COMMUNITY BOARD FEEDBACK PACKAGE

Business Name: Georgie's

Cafe Address: 161 8th Avenue, New York, NY, 10011

Application Number: 20260511010001

SECTION 1: Site Plan

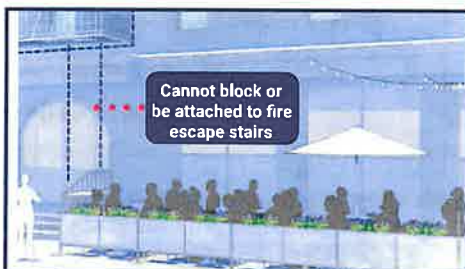
The proposed sidewalk cafe Site Plan does not allow the required clear path between the traffic signal and the cafe perimeter on the 8th Avenue side of the cafe. To remedy this issue, the applicant has agreed to remove one table with 2 seats from the 8th Avenue corner of the cafe, as reflected on the attached Revised Site Plan.

The proposed sidewalk cafe Site Plan does not allow the required clear path between the traffic signal and the cafe perimeter on the 8th Avenue side of the cafe. To remedy this issue, the applicant has agreed to remove one table with 2 seats from the 8th Avenue corner of the cafe, as reflected on the attached Revised Site Plan.

☒ Applicant acknowledges and agrees to modifications relating to the above referenced application
